## Road Infrastructure Design Report

### Park West SHD

### Park West Avenue and Park West Road, Park West, Dublin 12

**ROAD INFRASTRUCTURE DESIGN REPORT**

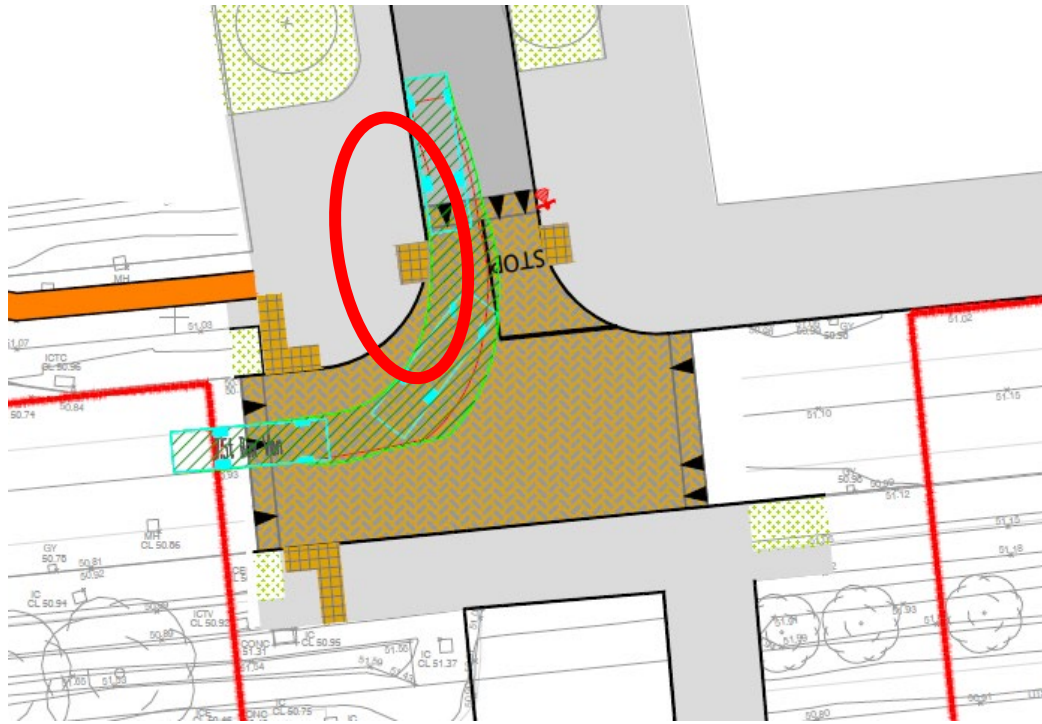
The swept-path analyses provided show vehicles overrunning the kerblines and the tactile paving or crossing the centrelines at both junctions that provide access to the development. During the site visit it was noted that vehicles using the existing access scuff/damage the kerbs. A vehicle mounting kerbs could strike a vulnerable road user. Given the size of the development the accesses may be busy at certain time with traffic entering and exiting simultaneously.

Revise the layouts of these junctions to ensure that all vehicles can pass each other and can make turning movements without the need to routinely overrun kerb lines.

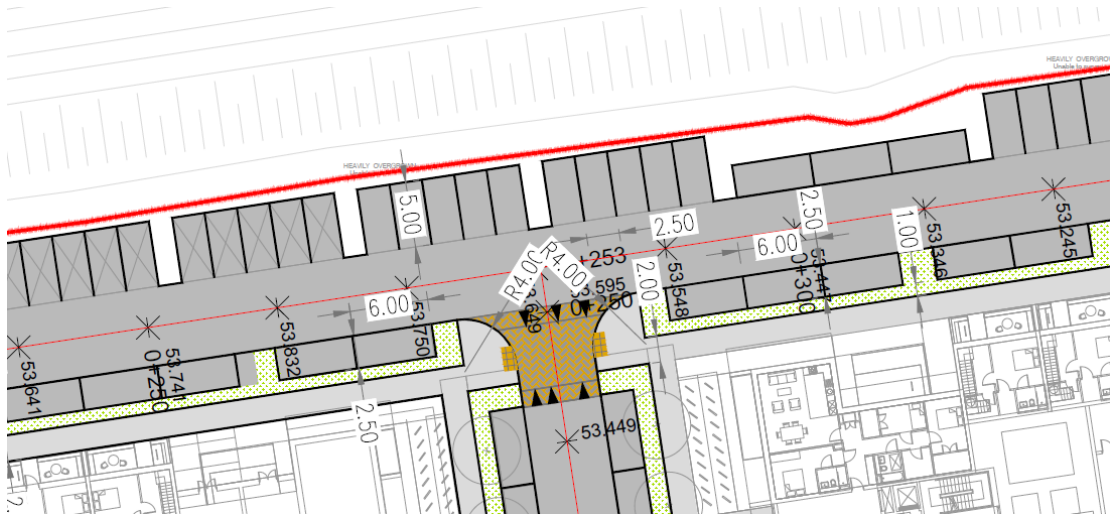
Perpendicular parking is provided opposite minor roads at internal junctions and car park accesses. The junction of Road 2 and Road 4 will be busy. Drivers exiting a parking space at the junction need to check in three directions for conflicting traffic. Drivers turning at the junction may not be alert to the possibility of a vehicle reversing from a parking space. These factors increase the risk of collisions between vehicles or with other road users.

Omit parking within the junction or change to use of parallel parking.

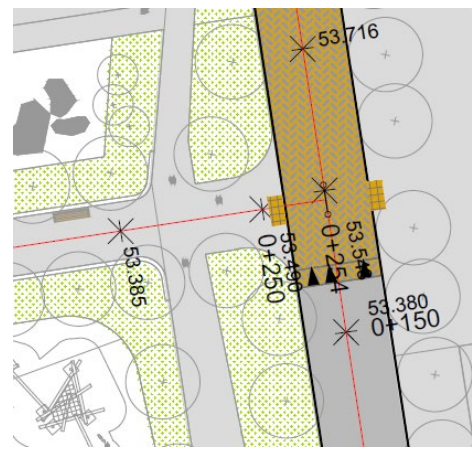
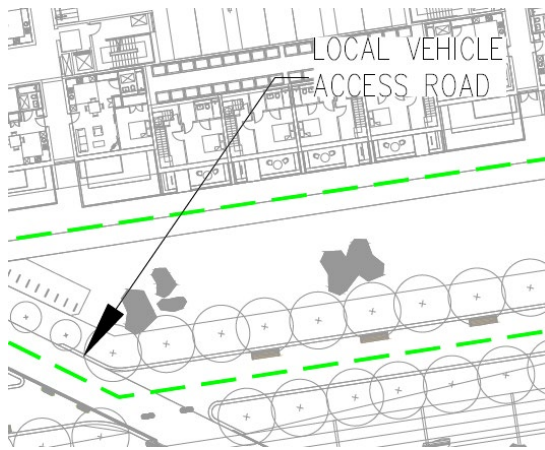
The priority of the various turning movements at the junction of Road 2 and Road 4 is not shown to be regulated (see image above). It will be a busy junction, and given the layout of the development, most traffic movements will be between the west and south arms. It is not clear how it is intended that the junction should be used. Driver uncertainty increases collision risk.

Provide measures to regulate traffic at the junction.

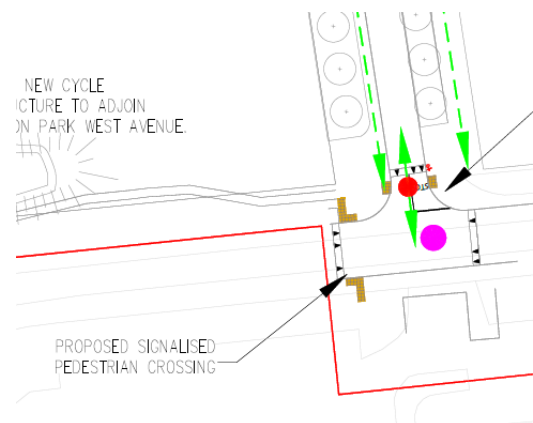
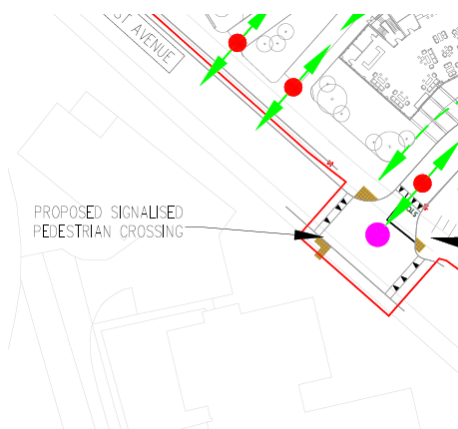
The proposed signalised pedestrian crossings shown to be provided at each of the two accesses to the development are located too close to the adjacent junctions. Crossings should be located away from conflict points at uncontrolled junctions. When the vehicular stage changes from red to green at the signals conflict between mainline ahead traffic and traffic exiting the adjacent minor road could occur.

Amend the layouts. The signalised crossings could be moved away from the junction turning area or the complete junctions could be signalised.

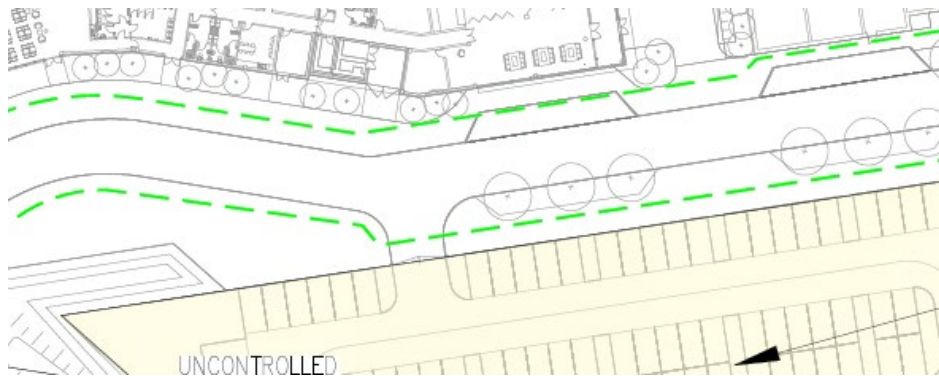
There is an abrupt change in the alignment of the mainline on Road 1 at the access to the new car park for the hotel. Drivers may fail to stay in lane and could conflict with traffic turning at the car park access.

Amend the layout to provide adequate horizontal curvature.

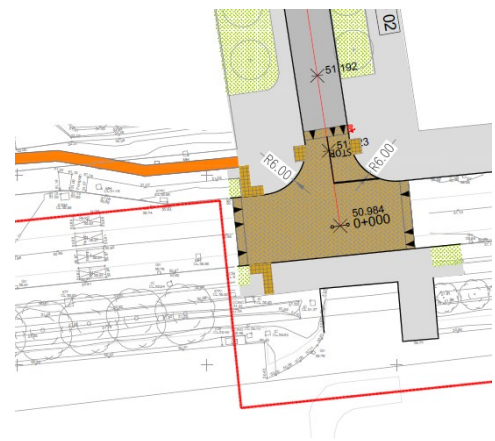
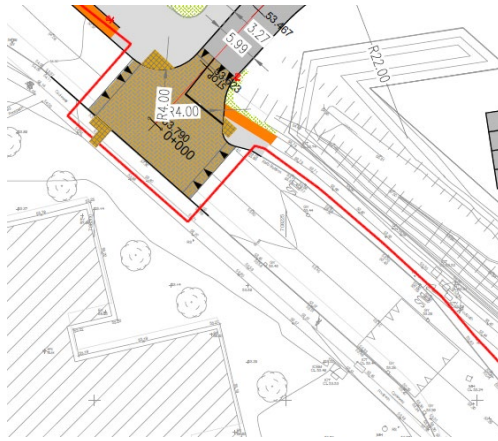
Road 1 is long, straight and has no features to calm traffic. Speeds may be excessive.

Provide traffic calming measures, as have been provided on Roads 2 and 4.

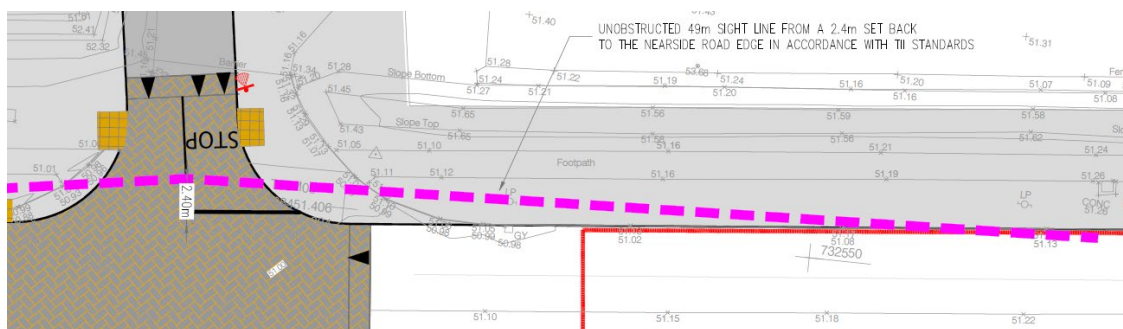
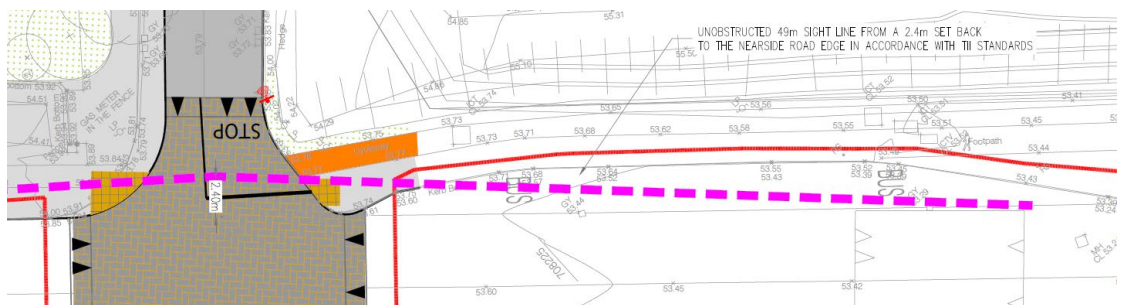
There are existing bus bays beside the accesses on both Park West Road and Park West Avenue. The visibility splays of the accesses slightly encroach into the bays with the result that visibility could be restricted by a parked bus. The accesses will be busy at peak times and drivers exiting the development may feel under pressure to turn onto the mainline even when visibility is restricted.

**Figure 13- On Street Formal parking**

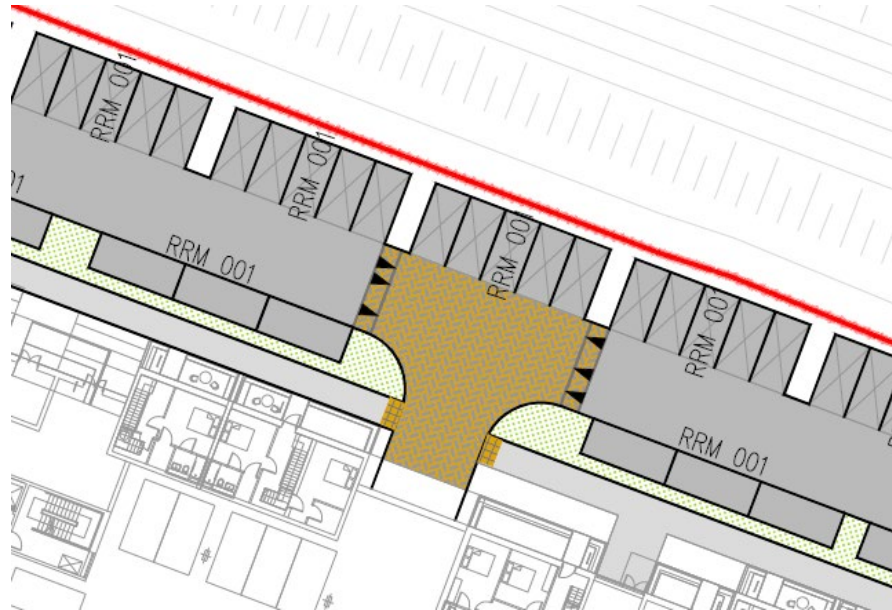
There is no footpath connection provided between the perpendicular car parking on the northern perimeter of the site and the dwellings opposite. It is not clear how pedestrians are intended to travel between the car parking and the dwellings. There is a continuous landscaped verge along the south side of Road 4 which would be an impediment to easy pedestrian movement, particularly for the mobility impaired.

Revise the layout to provide facilities for pedestrians to travel with ease between the dwellings and the car parking.

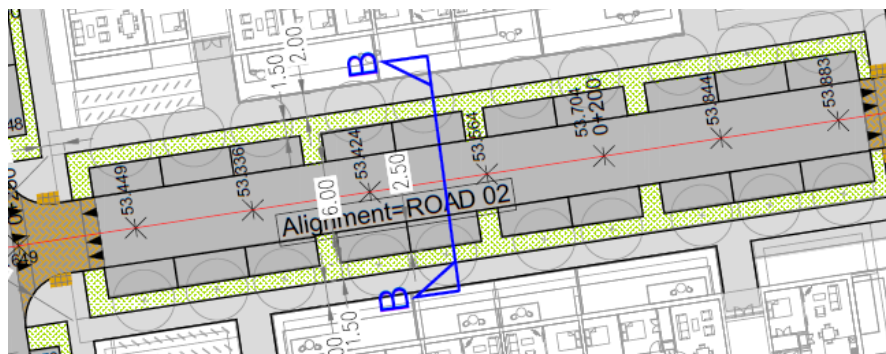
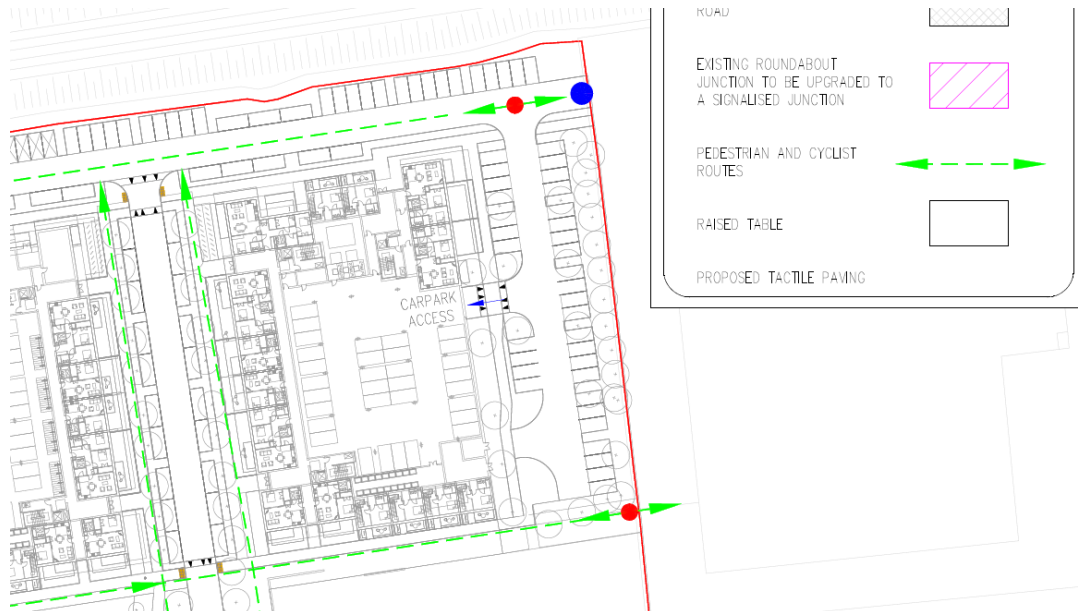
A landscaped verge is shown to be provided between parallel parking spaces and the footpath; in some cases it is shown to contain trees. Passengers will alight onto the verge, which may provide unsuitable footing, particularly during the winter.

Use hard landscaping wherever regular pedestrian traffic will be present.

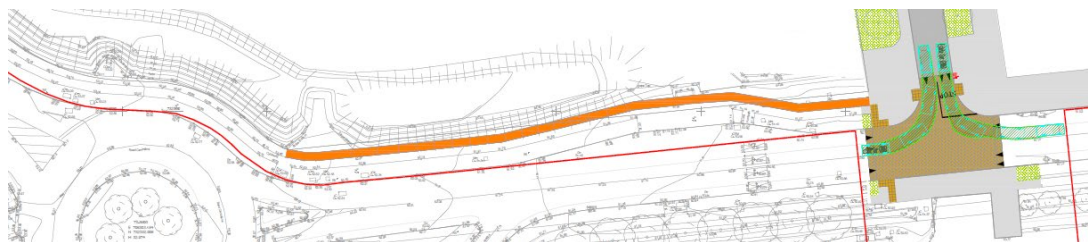
Along the western boundary of the site the existing footway is located on the carriageway side of the cycle track (the footway and the cycle track change sides at the railway bridge). This layout is unconventional, and the drawings show it to be changed on the section north of the hotel access. However, the section south of the access is to be retained, and a new section is to be built between the roundabout and the Park West access that is to have the same unconventional layout. This may be confusing for cyclists and may increase the potential for conflict with pedestrians.

At all locations along the boundary of the site, place the cycle track between the carriageway and the footway, to provide a layout that is in line with the guidance of the National Cycle Manual.

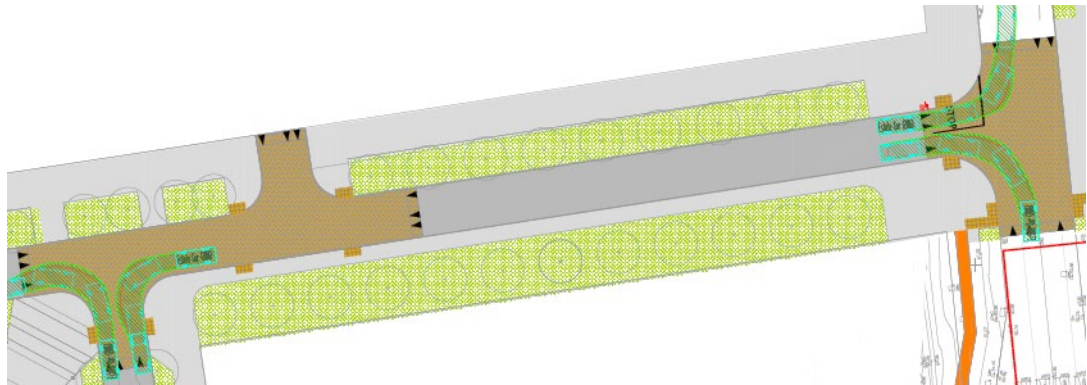
The accesses will be busy in peak periods and there may be queued traffic on the exits from the development. Cyclists may choose to use the footpath rather than wait in the queue, and this could affect pedestrian safety. It is likely that this would apply mainly to Road 2 (cyclists travelling to the north of the railway and to the west would use the pedestrian and cycle access at the bridge).

Provide cycle facilities on the section of Road 2 south of its junction with Road 3.

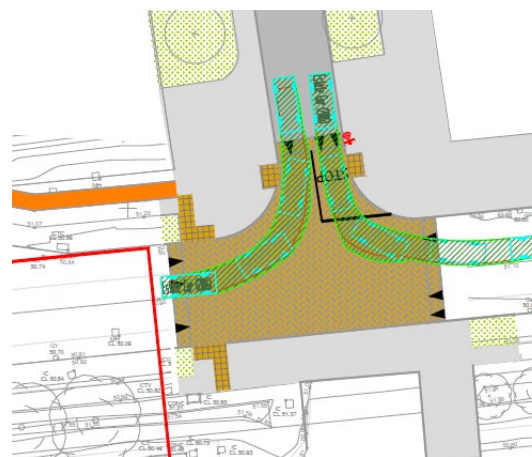
At both accesses the cycle lanes are shown to be terminated across the mouths of the junction. This would require cyclists to stop and give way to traffic exiting the development, and would negatively impact on the level of service provided by the cycle facility.

Make the cycle facilities continuous across the mouths of the accesses, as shown in the National Cycle Manual (detail: Side Road Joining Street with Segregated Cycle Facility, or similar)

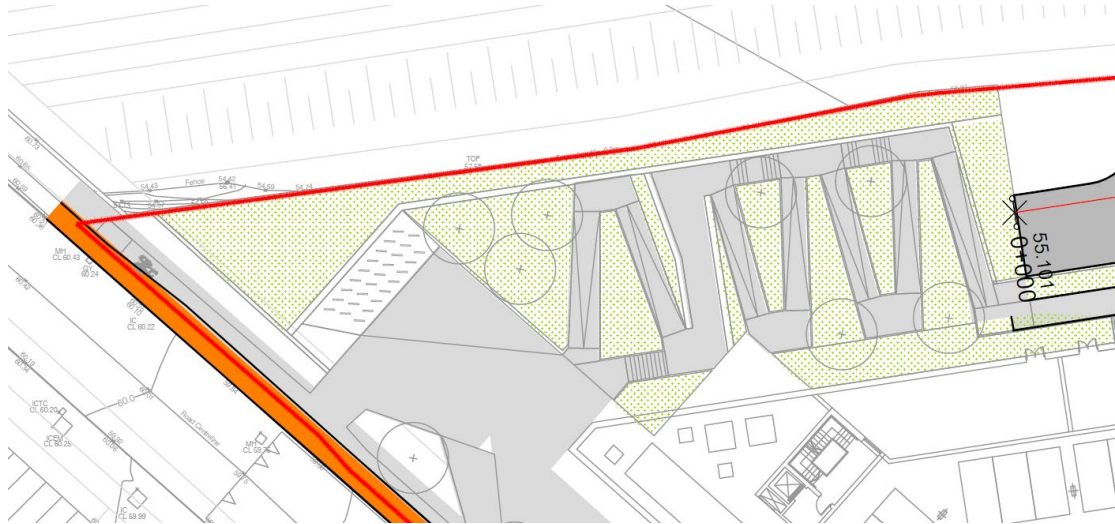
The new pedestrian/cycle entrance to the northwest of the site features steps and ramps. The locations where tactile paving is to be provided has been shown on drawings (at junctions and accesses within the development). None is shown at the location of the steps and ramps. Visually impaired users may not be provided with sufficient warning of the hazards associated with the steps, ramps and landings.

Provide tactile paving in accordance with 'Guidance on the use of Tactile Paving' and 'Building for Everyone'.
